In June 2017, the City of Red Deer Council approved a bylaw to realign the intersection of 67 Street and 30 Avenue, leaving approximately 10.5 acres of land (the "Site") to the south west of the new intersection as vacant developable land. Anders East Developments LP (managed by Melcor Developments Ltd. (Melcor)) has acquired the land and is planning a new commercial centre that will integrate with the existing first phase of Clearview Market Square. The second phase of Clearview Market Square will be a commercial retail centre building off the synergies of the existing development.

Revised DC (27) - Zoning Bylaw Amendment

18.20.7 Direct Control District No. 27 Neighbourhood Centre DC (27)

Site Plan

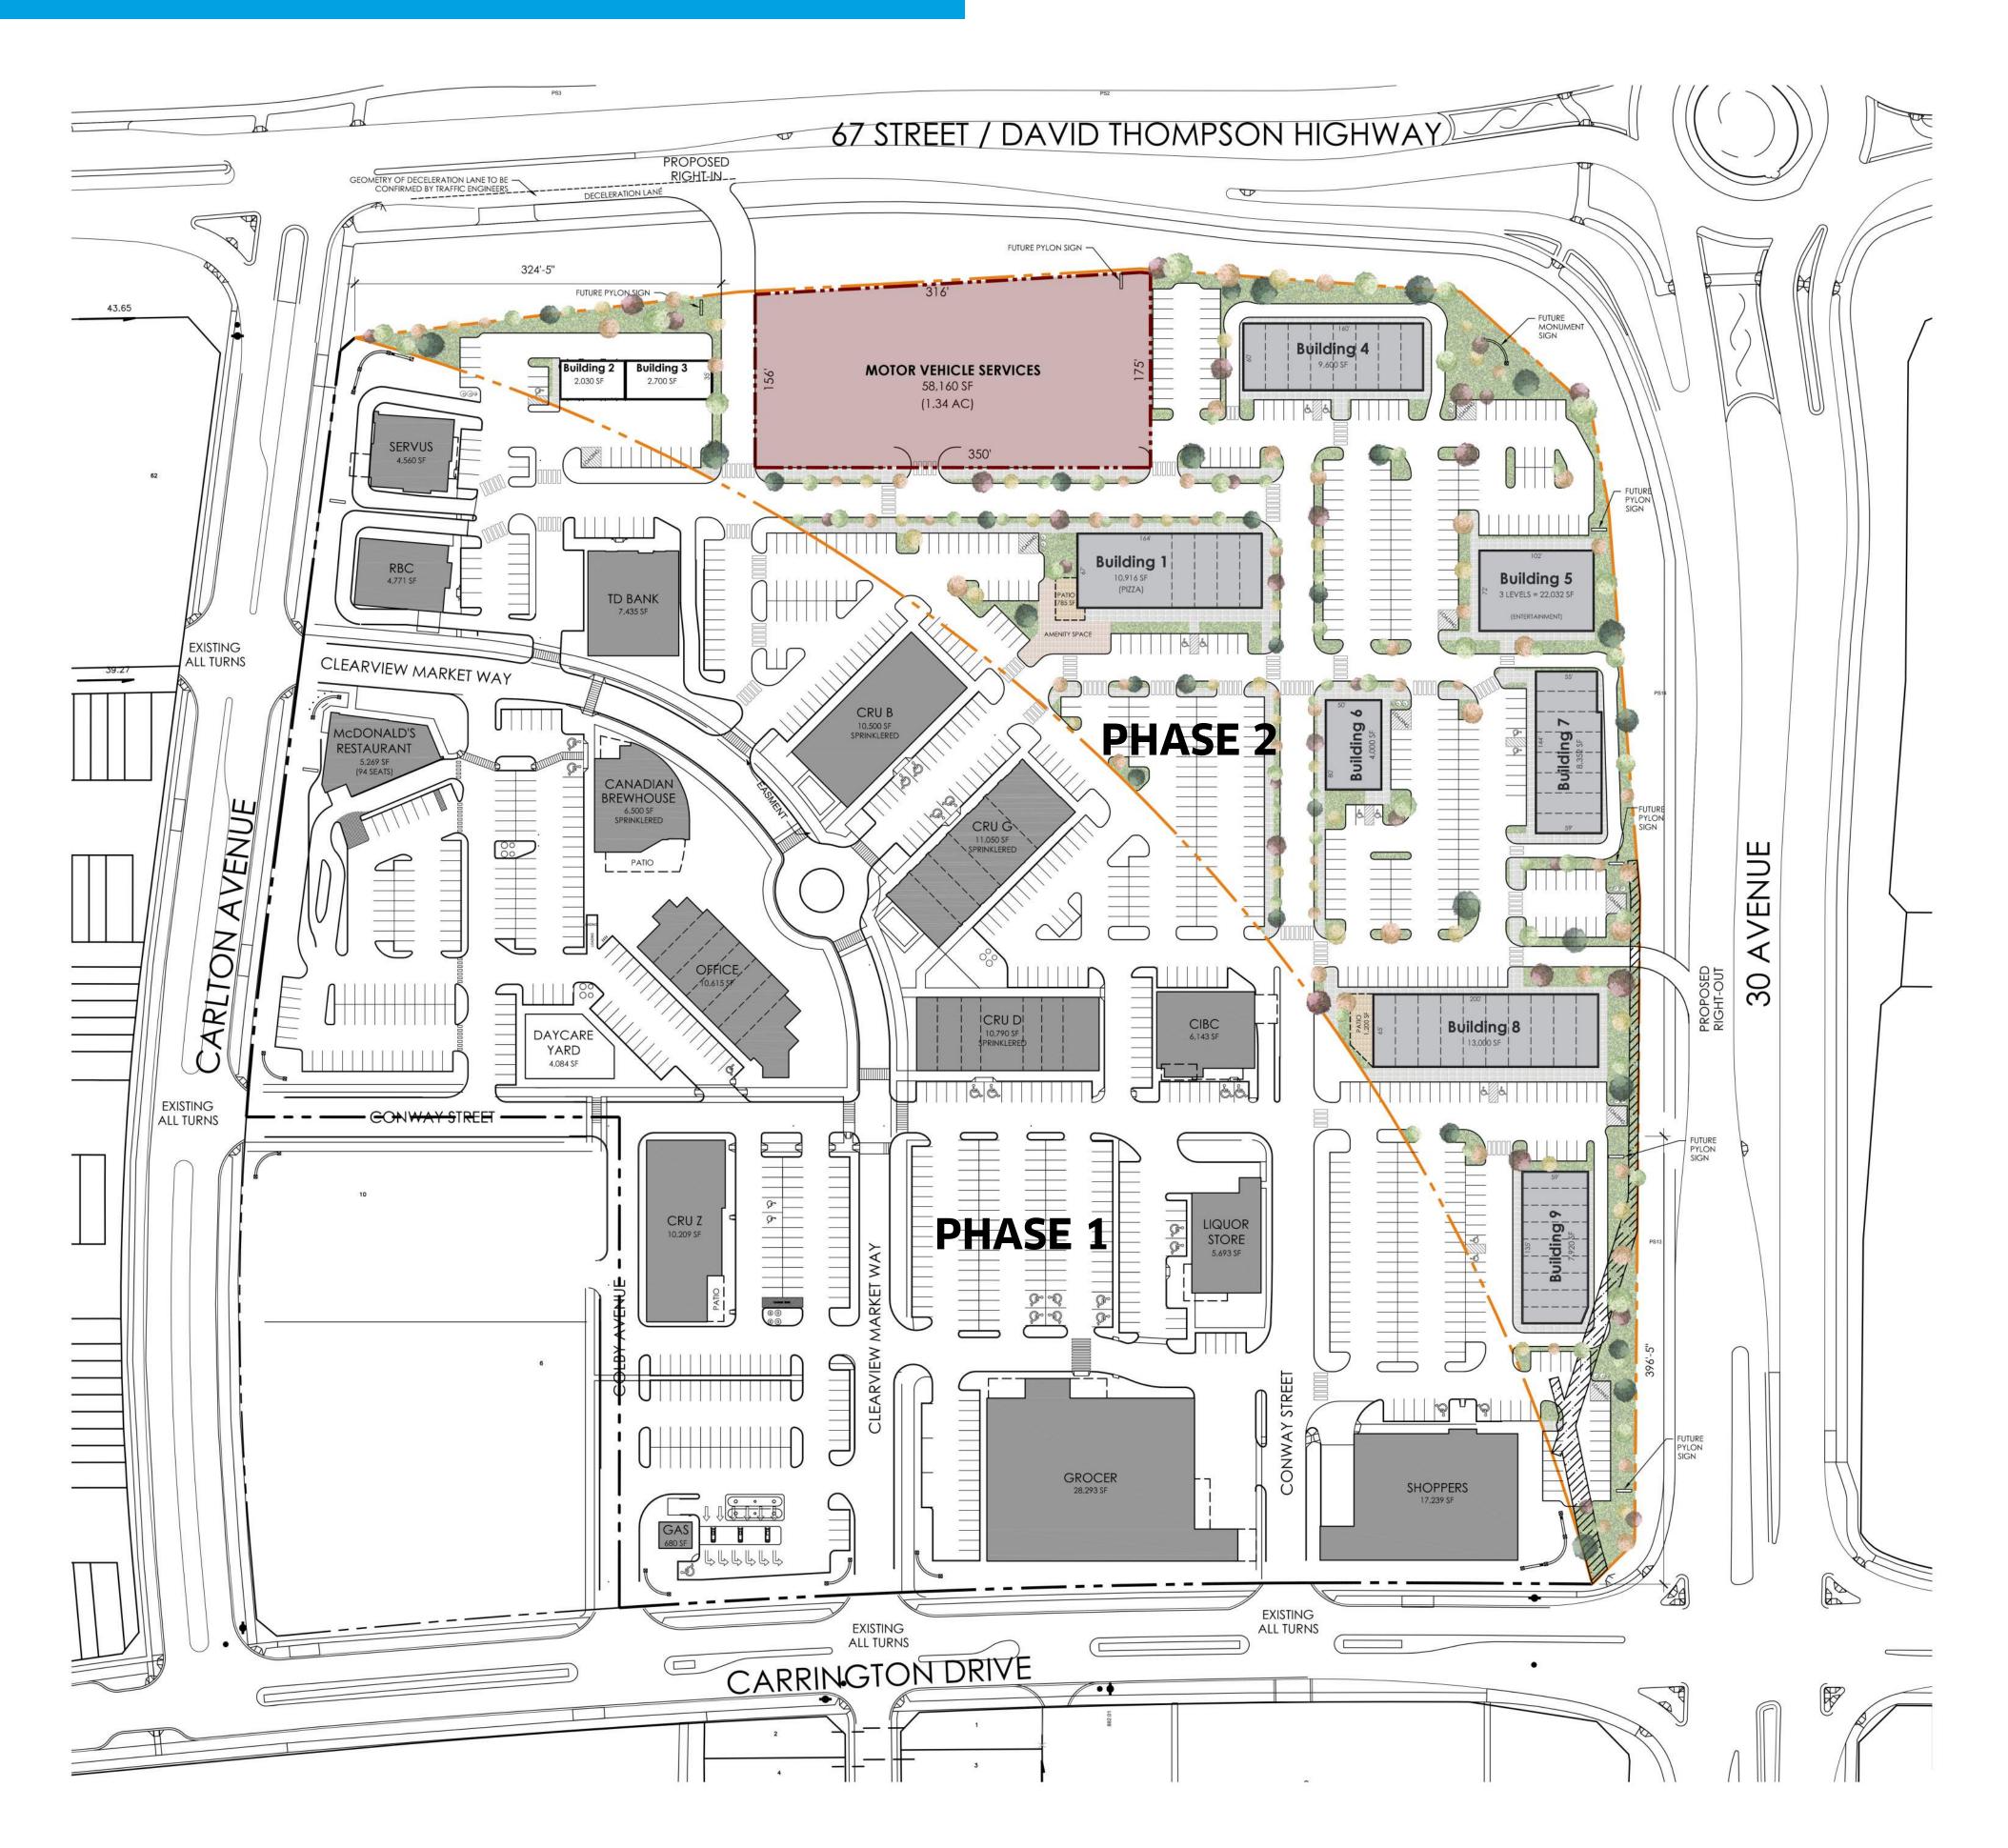
Several tenants of Clearview Market Square have expressed interest in understanding the existing and future relationship between buildings, parking, and pedestrian area. In July 2017, Council rescinded a portion of the originally approved site plan and design package for the next phase of development, to allow these items to be addressed with a new site plan and input from the existing tenants. Melcor is also seeking to amend the DC-27 to incorporate the updated site plan and to increase the likelihood that additional uses could be included in Phase 2. By doing so this will help to provide a broader range of services to the surrounding community. These amendments include:

- There is no lube shop or tire shop in Phase 1.
- - establishments).
- Other minor revisions to update the DC27 with the plans for Phase 2.

• Allowing for Motor Vehicle Services as a discretionary use such as a lube shop or tire shop.

• Giving the Development Officer the authority to approve Motor Vehicle Services and Restaurants with drive-throughs (discretionary uses), if they align with the site plan.

• There is only one drive through restaurant in Phase 1 (Drive-through restaurants may reduce parking demand as customers often do not park when they visit these

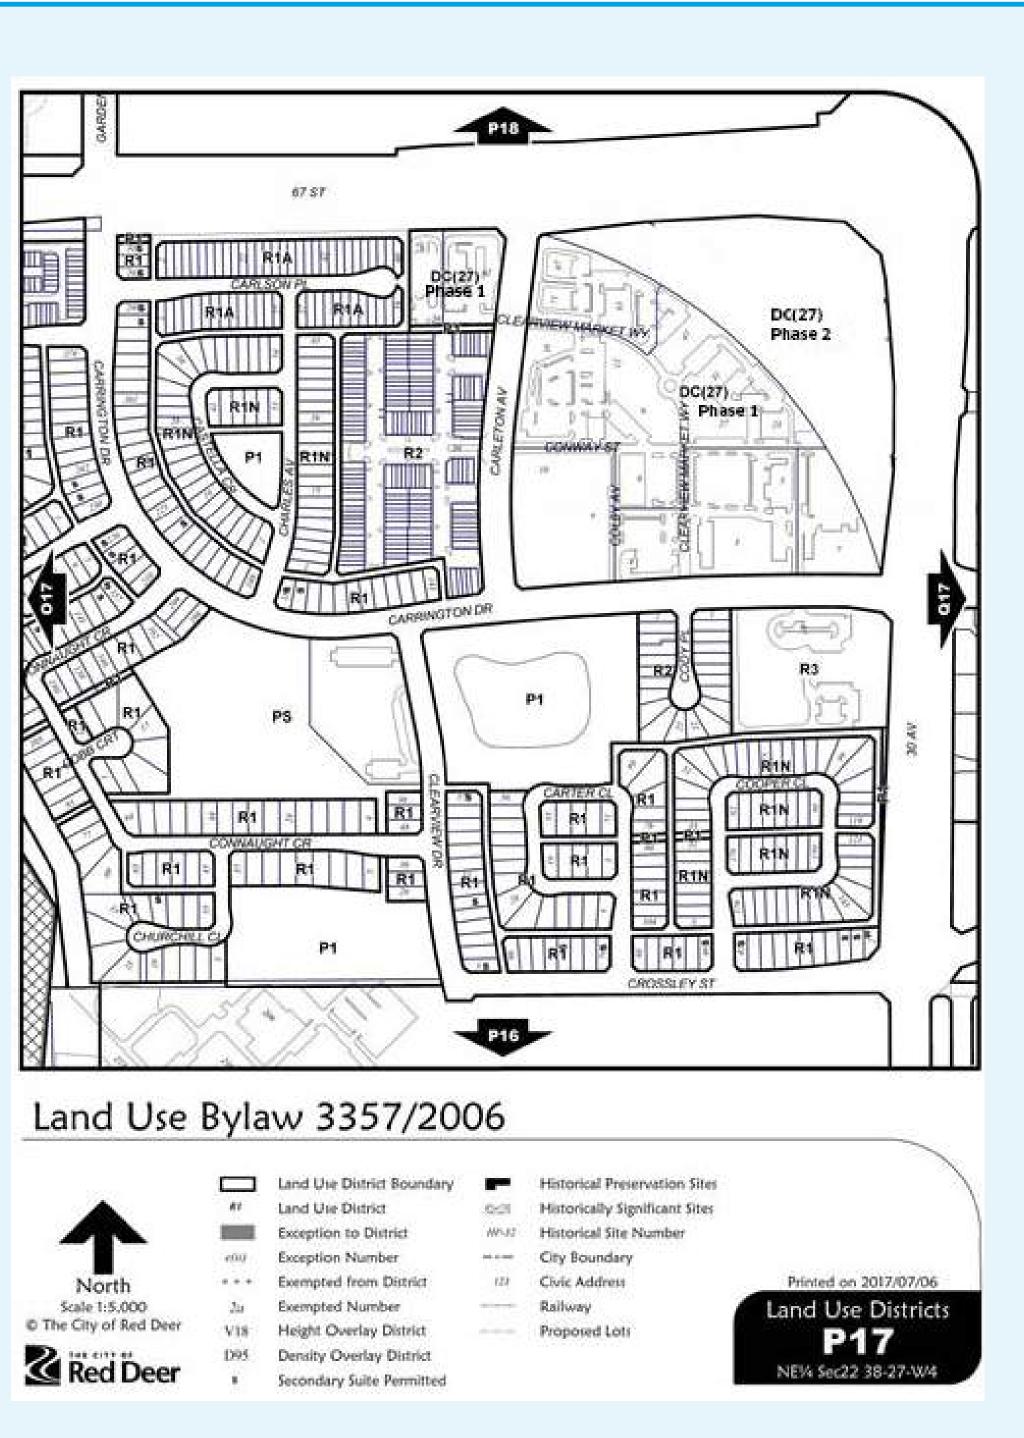
Revised the map to depict Phase 1 and Phase 2.
